Revisions to the Phase I Interim Report and Phase II Proposal

**CIBA-GEIGY Facility
Cranston, Rhode Island**

July 1993

TECHNICAL REVIEW - PHASE I INTERIM REPORT AND PHASE II PROPOSAL

DR. BY:	MG	SCALE:	AS SHOWN	PROJ. NO:	87X4660
CK'D BY:	MH	DATE:	21 OCT 1991	FIG. NO:	4-6

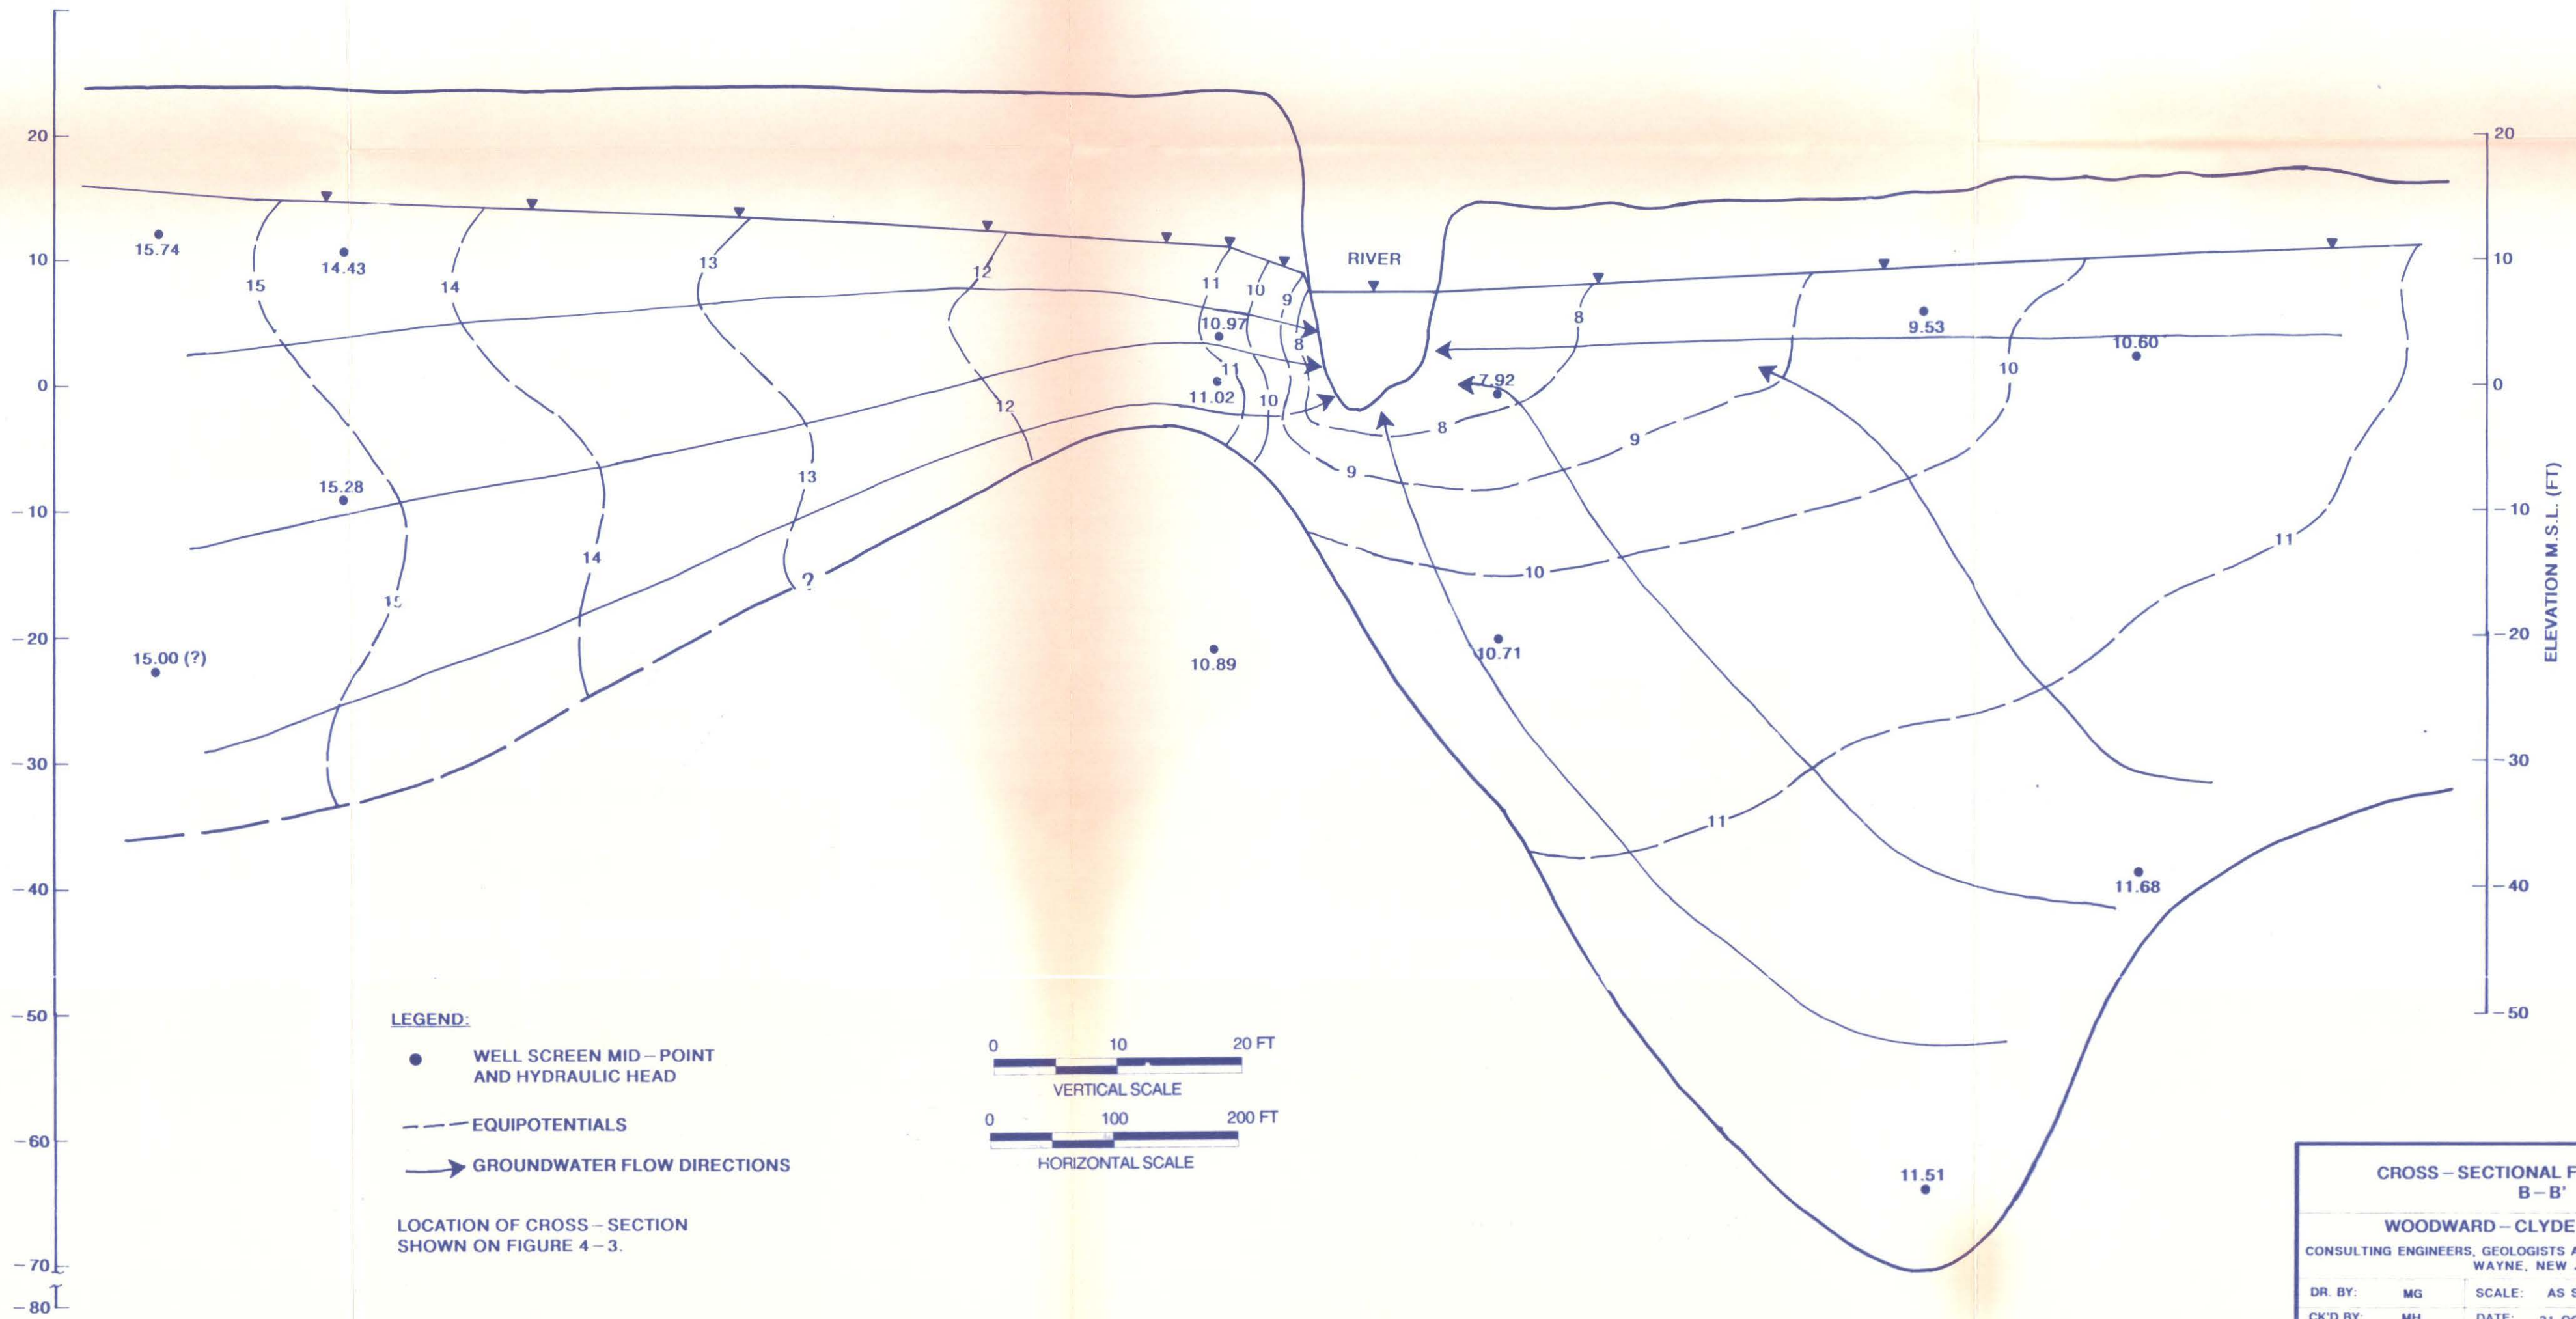
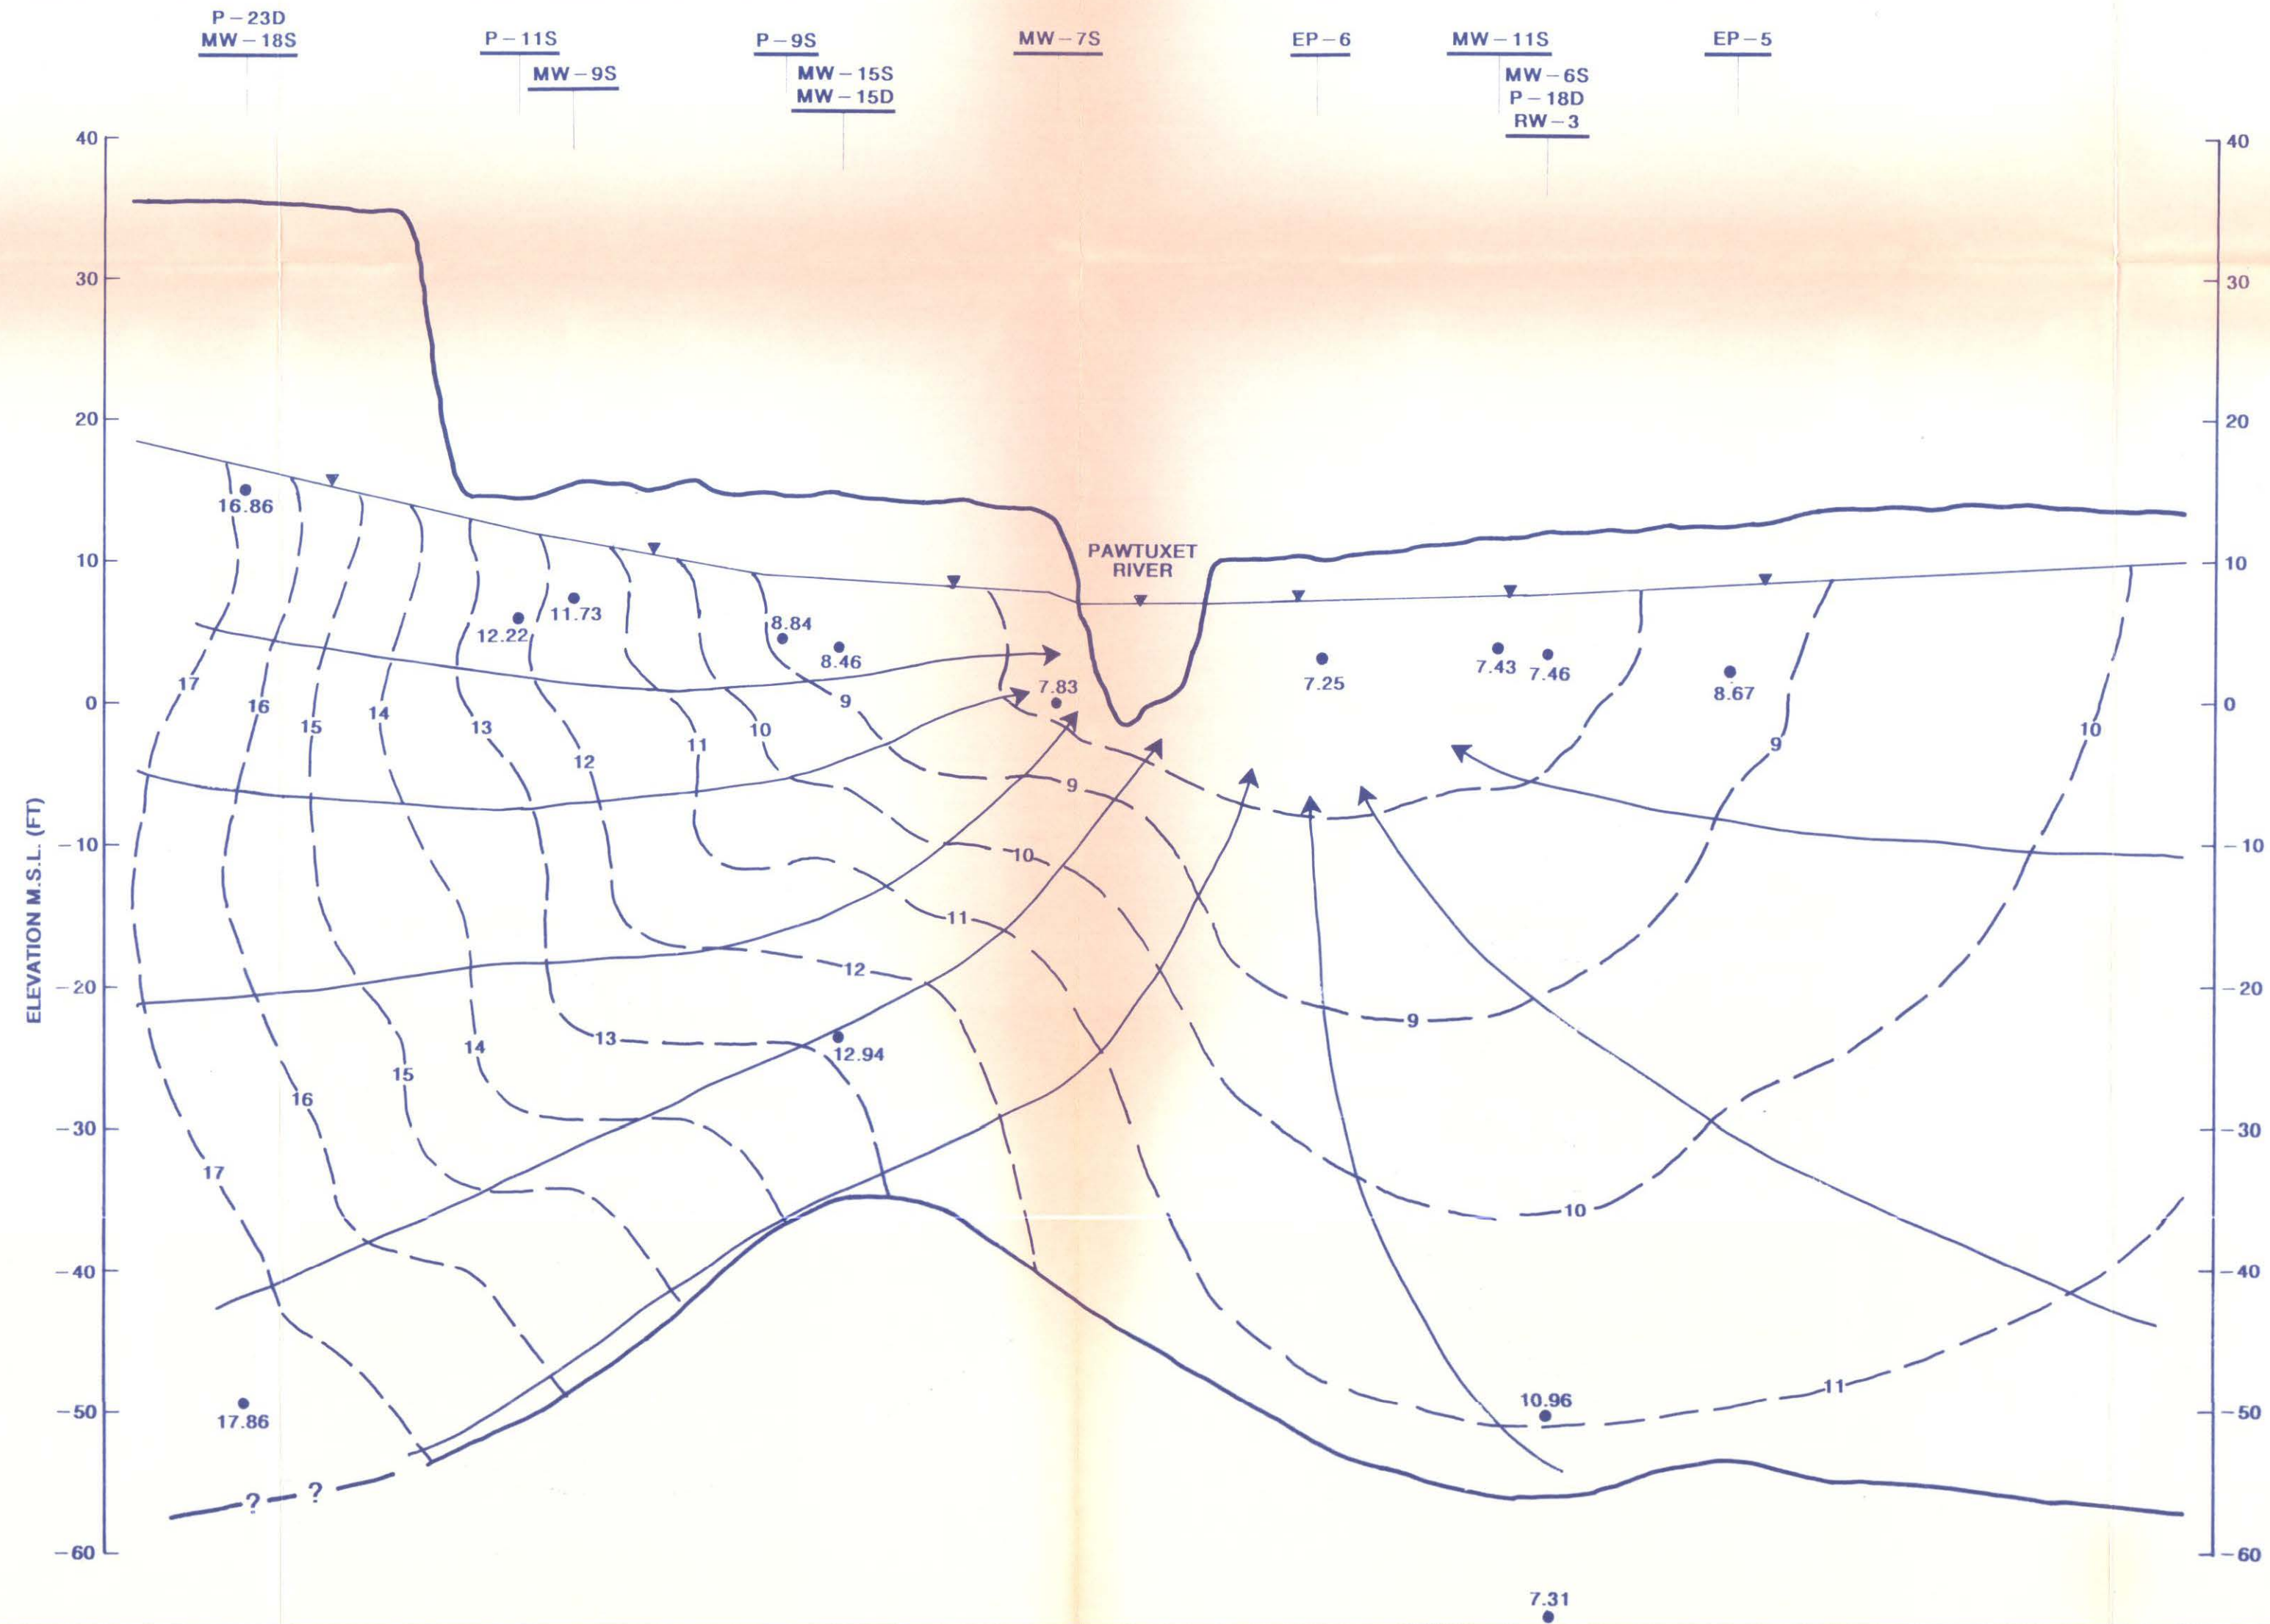
9. **Figure 4-6:** This cross section has several errors. The wells/piezometers P-14S, P-14D, MW-10S, MW-10D, P-13S, P-6M are not located in the same place where they are portrayed in plan view maps. It appears that the wells may be incorrectly labeled making the trace of this cross section unreasonable for making flow interpretations, since it is constructed along a sharp bend. This should be corrected.

The errors on this figure have been corrected (see revised Figure 4-6).
